### ADDENDUM-03

**Name of Work : Tender KNPCC-12:** Design and Construction of elevated viaduct and 5 Nos. elevated stations (viz. Agriculture University Station, Vijay Nagar Chauraha Station, Shastri Chowk Station, Barra-7 Station & Barra-8 Station) including Architectural Finishing, E&M work and special spans from end of ramp after Double Pulia Station to Barra-8 Station i.e., from chainage 3783.000m to 7528.566m and end of ramp in Depot to Agriculture University Station i.e., from chainage (-)297.460m to (-)855.339 on Corridor-2 of Kanpur MRTS Project at Kanpur, Uttar Pradesh, India.

**Reply to Pre-bid queries : Tender KNPCC-12**

**Summary Sheet of Addendum No.03: KNPCC-12**

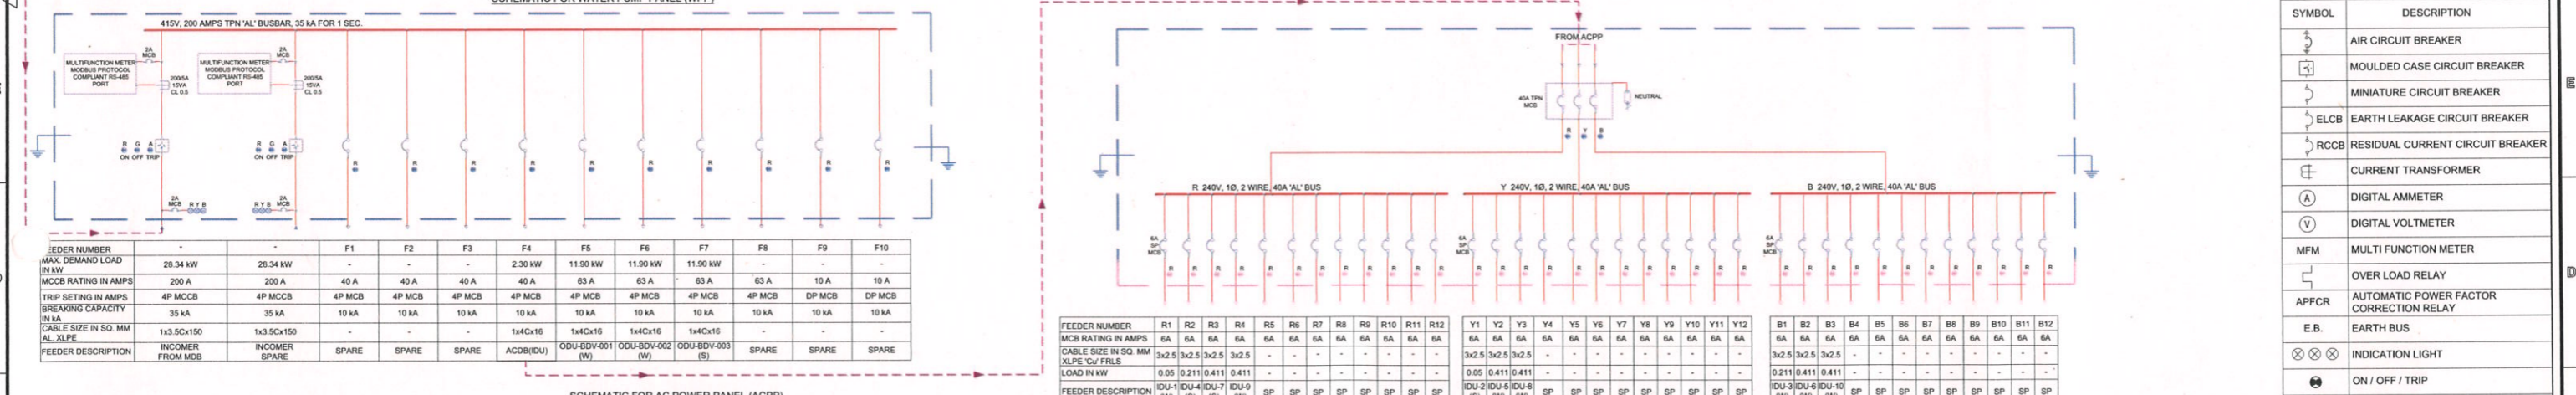
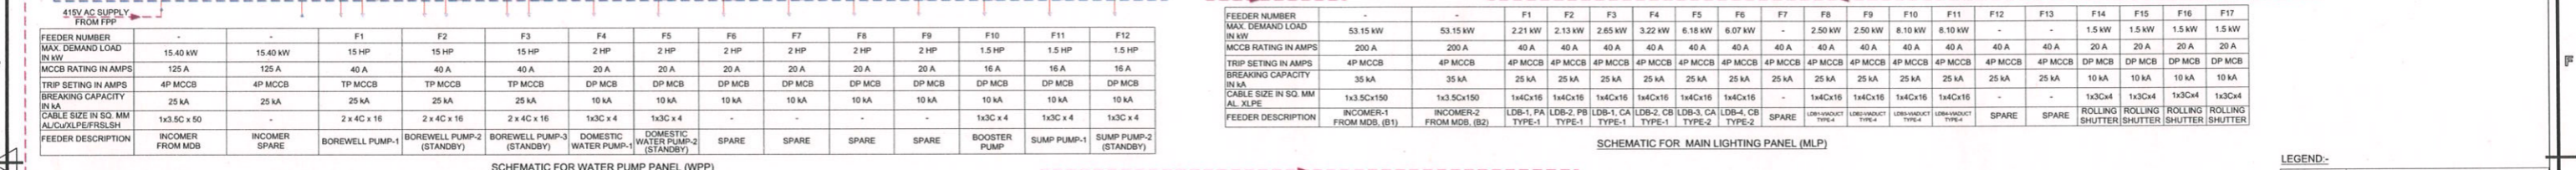
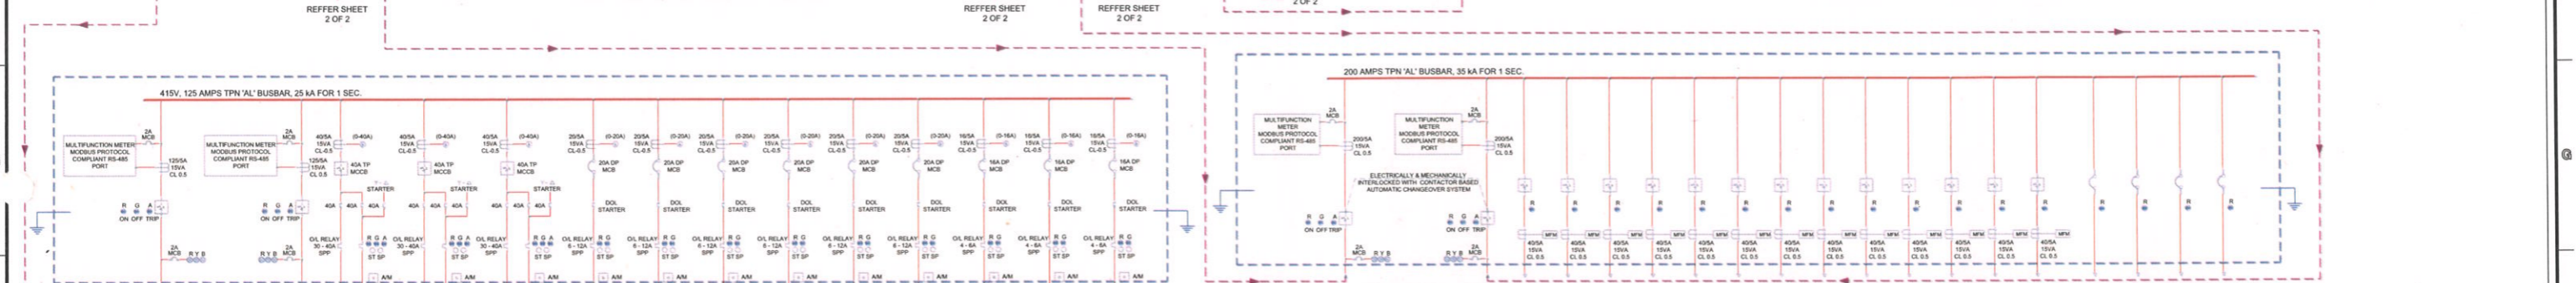
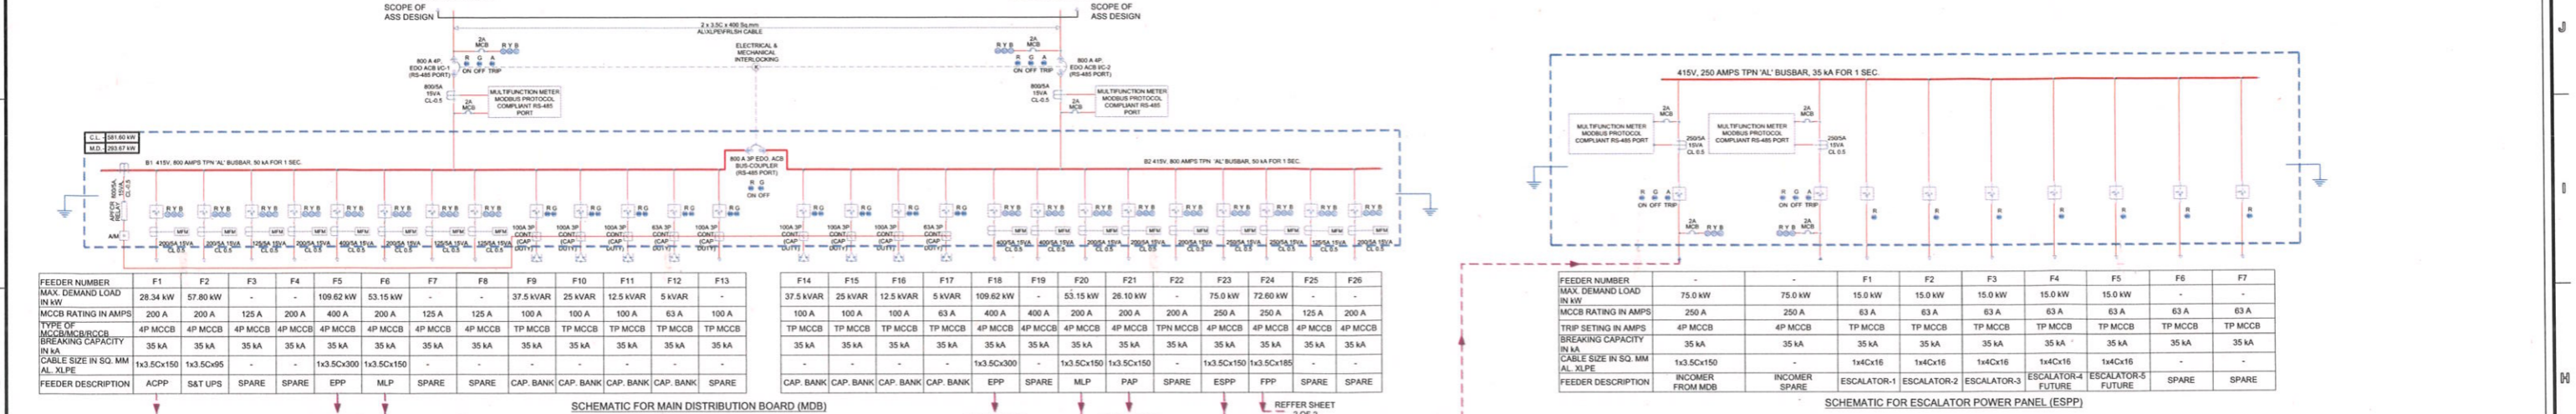
8	Vol 4, OCS, E&M		BMS Specification have been added.	Please refer Annexure -8 of Addendum-3
9	Vol. 6 Drawings	Drawings	Drawings has been revised as per attached index (no. of sheets 2)	Please refer Annexure -9 of Addendum-3
10	Volume 5 BOQ	Revised excel sheet of BOQ has been uploaded on CPP Portal

MAIN SCHEMATIC DIAGRAM FOR PANELS (SHEET 1 OF 2)

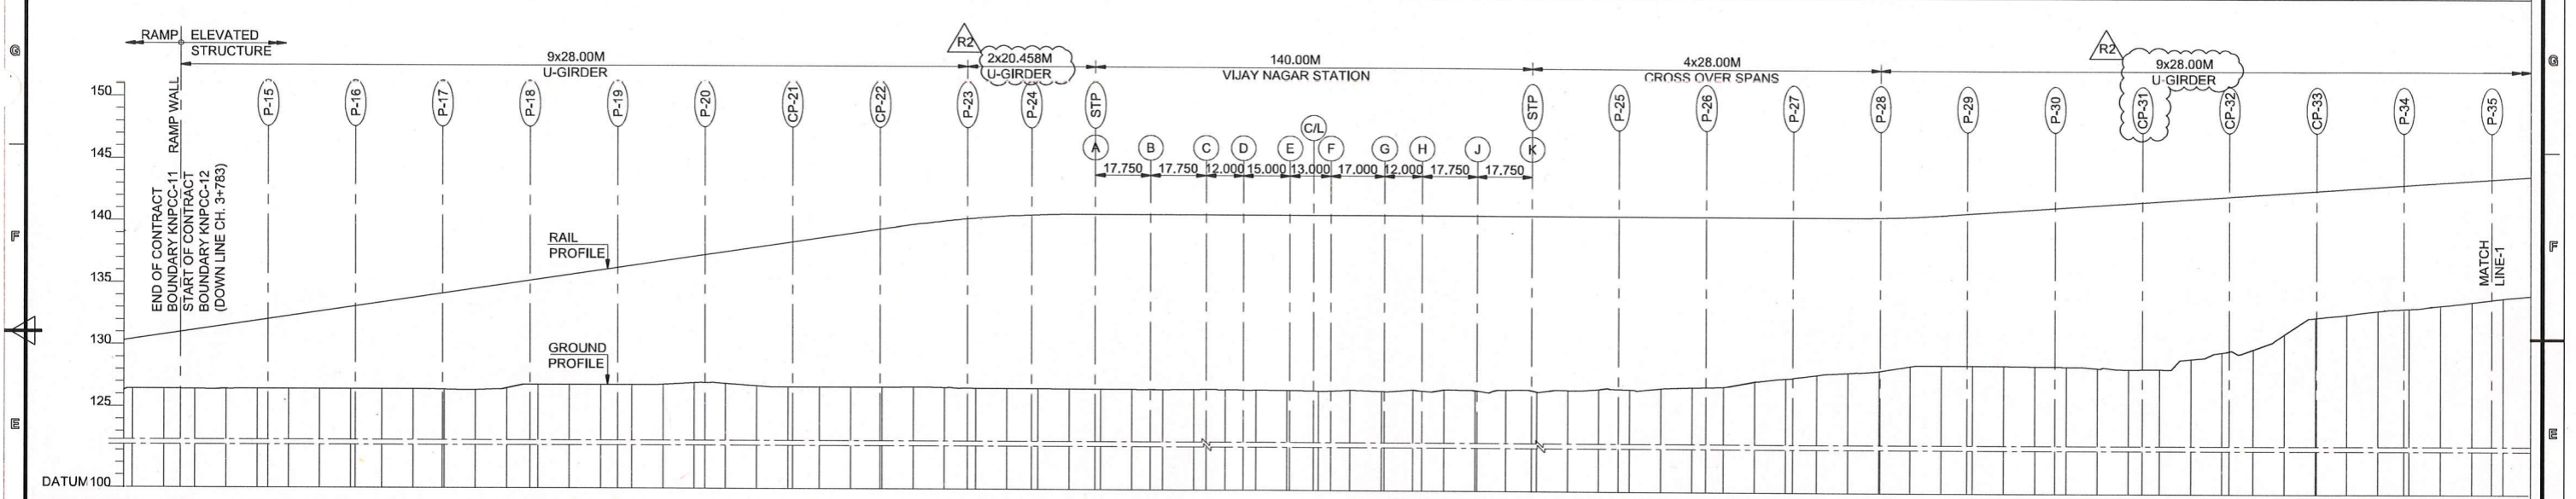
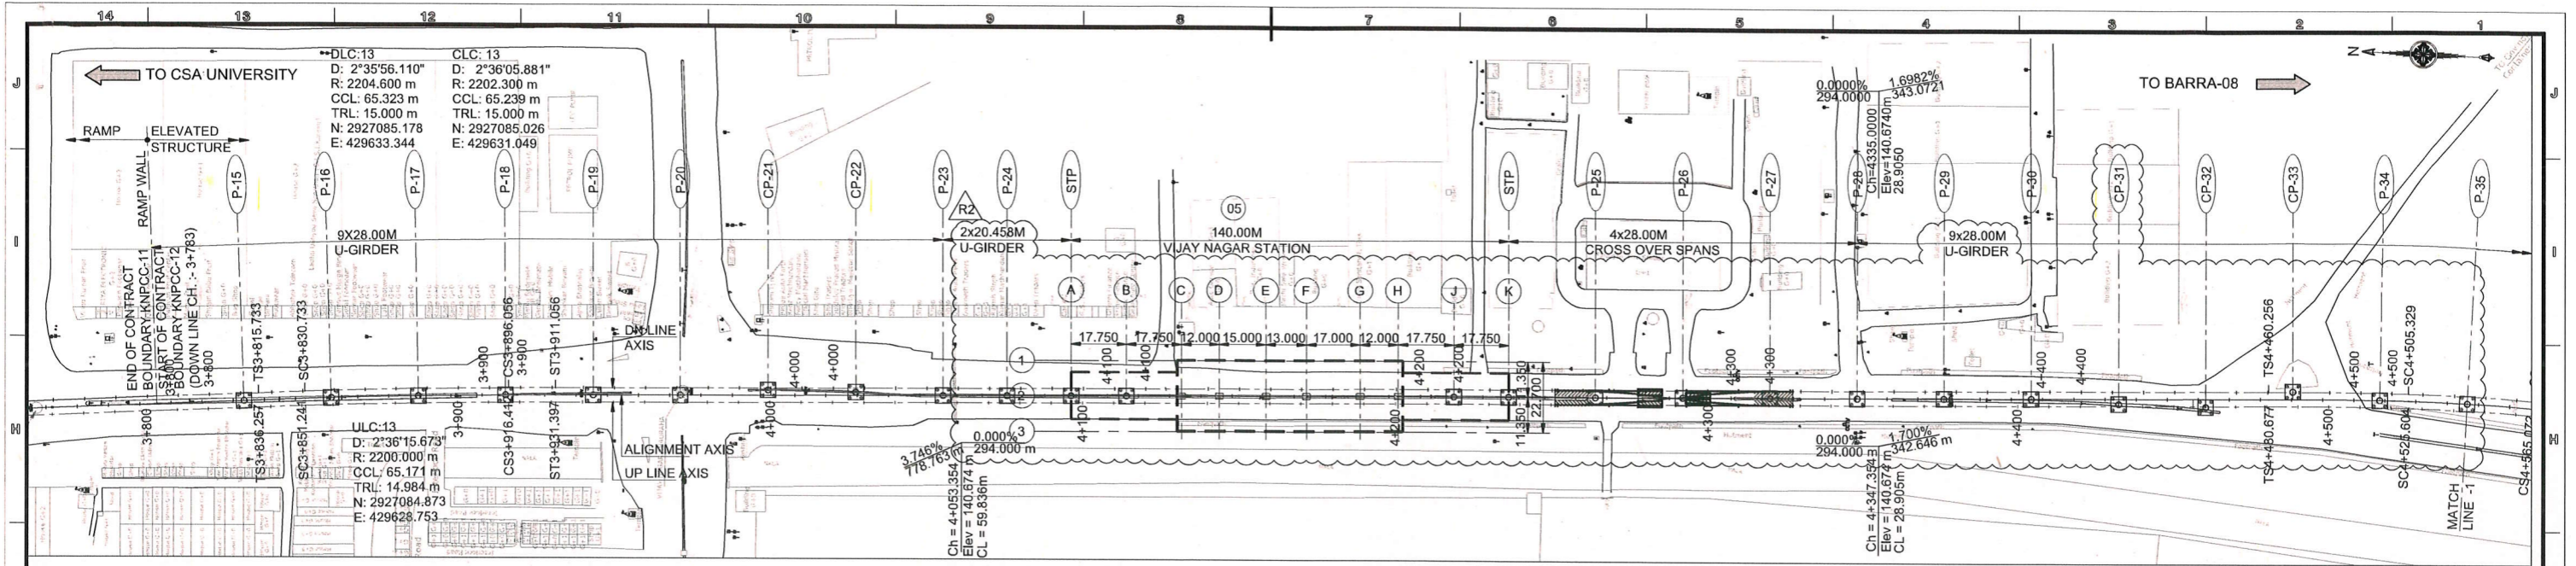
126	Vol_6_Drawing_1/Main Schematic diagram for Panels /Page No.01 & 02	Tie breaker	Bidder understands that, as per SLD 200A, a tiebreaker is considered between Busbar -1 and Busbar-2 for essential power panels, whereas the requirement is not captured in BOQ.	As per Tender Conditions.
127	VOL_6_Drawings	General	Request employer to provide BMS architecture for the stations below: 1. Agriculture University Station 2. Vijay Nagar Chauraha Station 3. Shastri Chowk Station 4. Barra-7 Station Barra-8 Station	Please find attached drawings.
128	VOL_6_Drawings	General	Request employer to provide BMS Tray layout for the stations below: 1. Agriculture University Station 2. Vijay Nagar Chauraha Station 3. Shastri Chowk Station 4. Barra-7 Station Barra-8 Station	Contractor to quote as per BOQ.
129	VOLUME 4, OCS & ODS & SOD	General	Request employer to provide technical specifications for Building Management System	Please refer Addendum 3.
